LONG ISLAND LIGHTING COMPANY

(Shoreham Nuclear Power Plant,
Unit 1).

SUFFOLK COUNTY'S EXHIBITS TO JOINT DIRECT TESTIMONY

CRANKSHAFT EXHIBITS
40-50
VOLUME 2

FIG 1 OVER

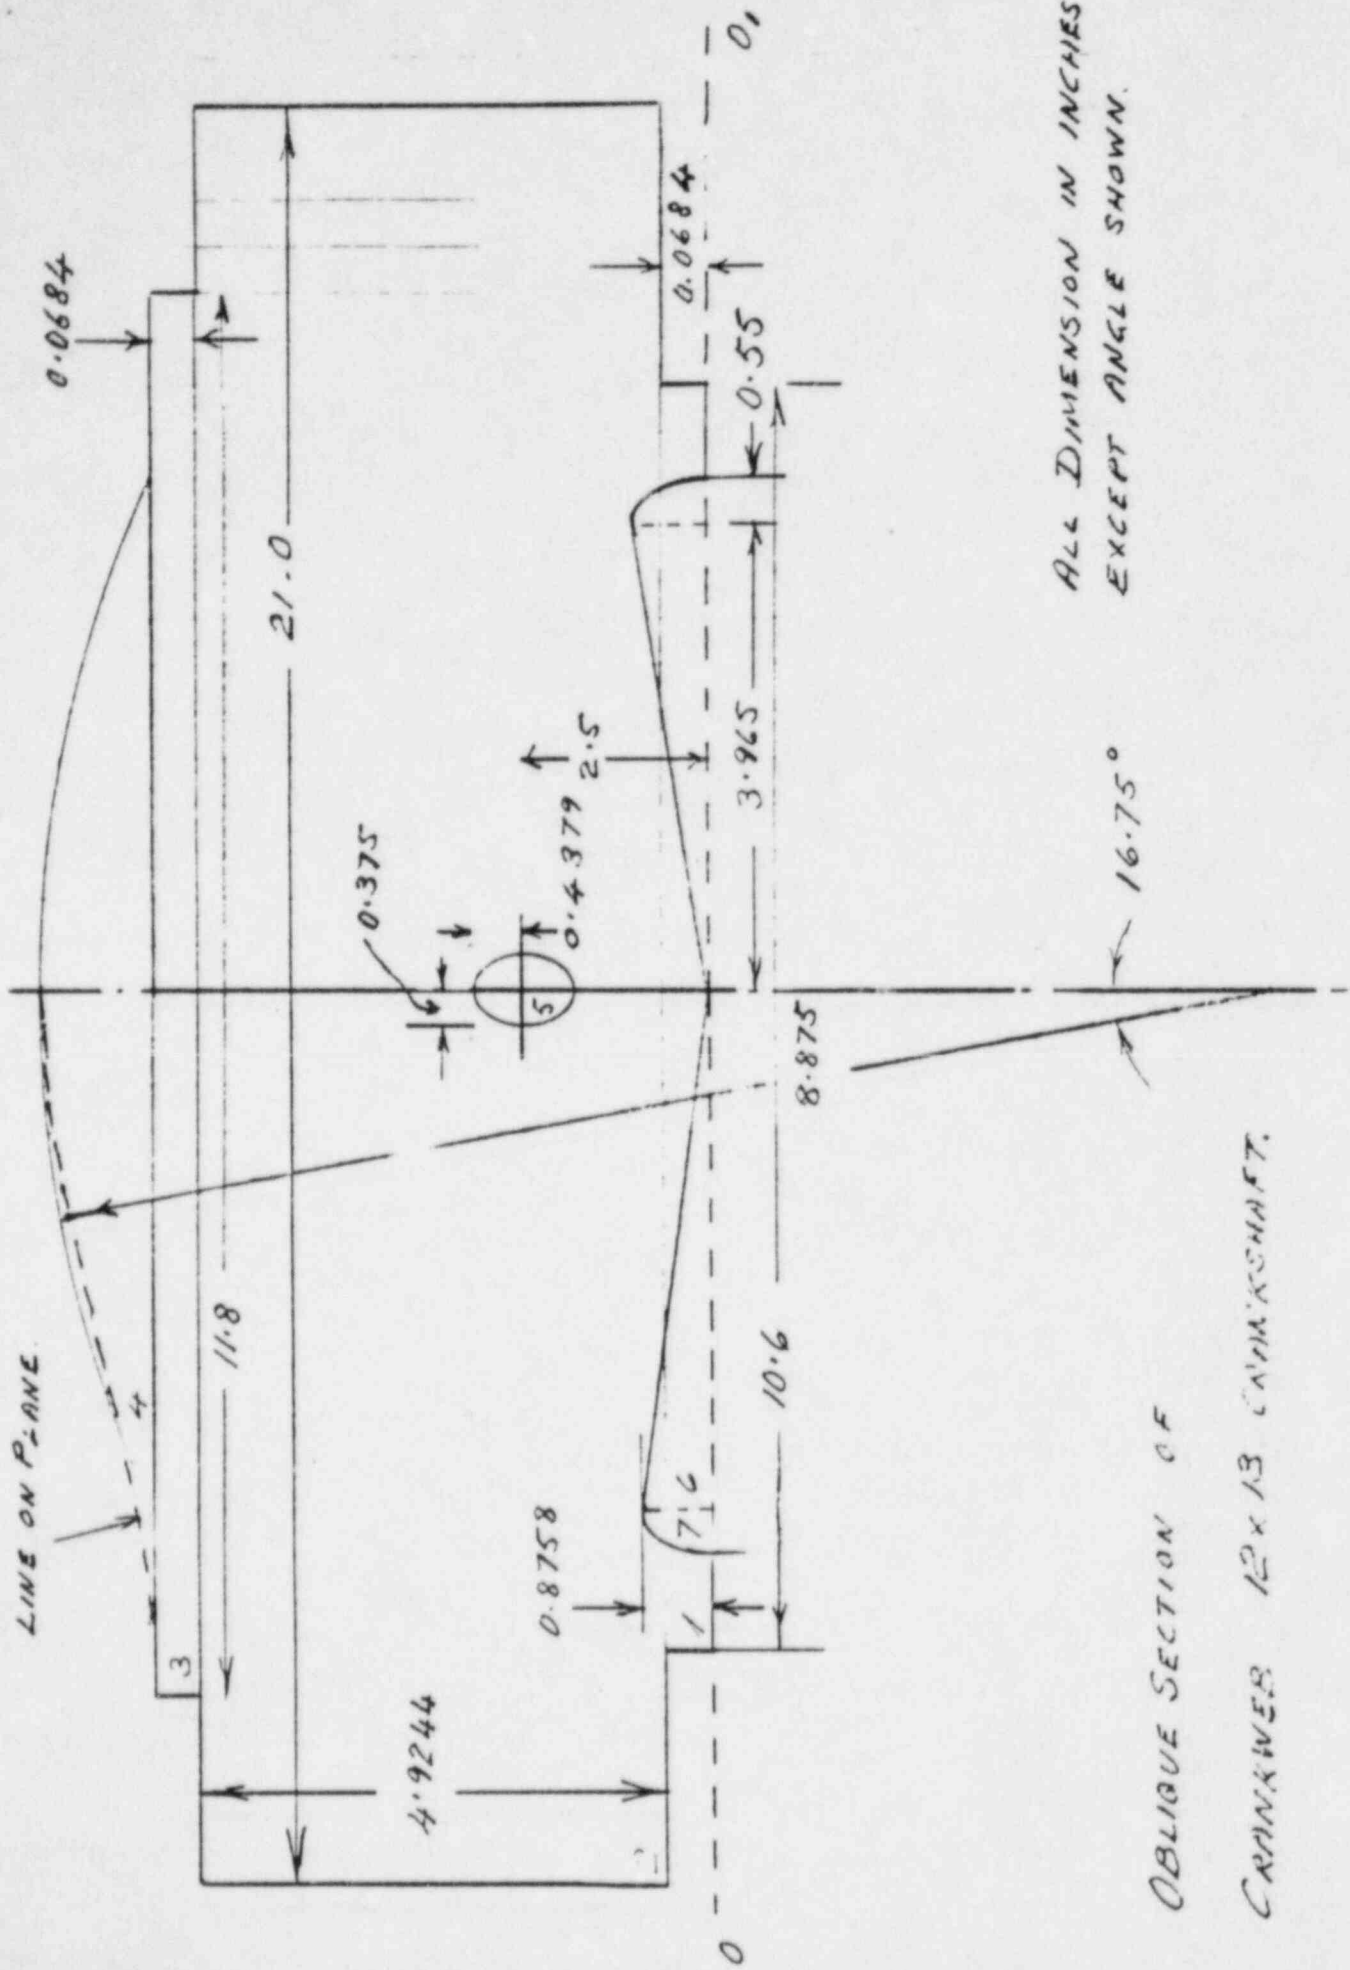
THE RE-ENTRANT FILLET ACTS AS A SERIOUS STRESS RAISER WHEN CONSIDERING THE OBLIQUE SECTION OF THE WEB UNDER THE ACTION OF BENDING. THIS HAS BEEN SHOWN TO BE TRUE IN THE SECTION OF THE WEB OF THE FRACTURED CRANKSHAFT. THE NUCLEATION SITE OCCURRED AT THE BOTTOM OF THE RE-ENTRANT FILLET.

IS PRECLUDED AS THE EFFECTIVE RESISTING MOMENT CANNOT BE OBTAINED FROM THE RECTANGLE CREATED BY W AND t

THE EFFECTIVE MOMENT OF INERTIA OF THE SECTION ON THE OBLIQUE PLANE CAN ONLY BE OBTAINED BY SUMMATION METHOD.

THE OBLIQUE PLANE REQUIRES GEOMETRICAL DEVELOPMENT TO OBTAIN THE BOUNDARY OF THE RE-ENTRANT FILLET AND THAT PART OF THE JOURNAL FILLET CUT BY THE OBLIQUE PLANE.

THE OIL PASSAGE WILL ALSO HAVE AN EFFECT WHICH MUST BE CONSIDERED AS IT WILL BE NEGATIVE IN VALUE. THE TRUE NEGATIVE VALUE WILL BE DEPENDENT ON THE DISTANCE OF ITS CENTER FROM THE NEUTRAL AXIS.

SEE FIG. 1 FOR SKETCH OF SECTION THROUGH JOURNAL ON OBLIQUE PLANE AT 23.9625° SAY 24° TO PIN AXIS.

FROM THIS IT CAN BE SEEN THAT THE WEB STRENGTH IN BENDING IS EQUIVALENT TO A

PIN OR JOURNAL DIAMETER OF 10.9337 INCHES.

FROM THIS IT IS SEEN THAT THE MOMENT OF RESISTANCE ON THE OBLIQUE SECTION IS A VERY CRITICAL FIGURE IN THE STRENGTH OF THE CRANKSHAFT.

THE STRENGTH OF THE WEB IS VERY CRITICAL WHEN RELATED TO MAXIMUM CYLINDER PRESSURE

THE CRANKSHAFTS DO NOT MEET ABS RULES FOR 4890 HP.
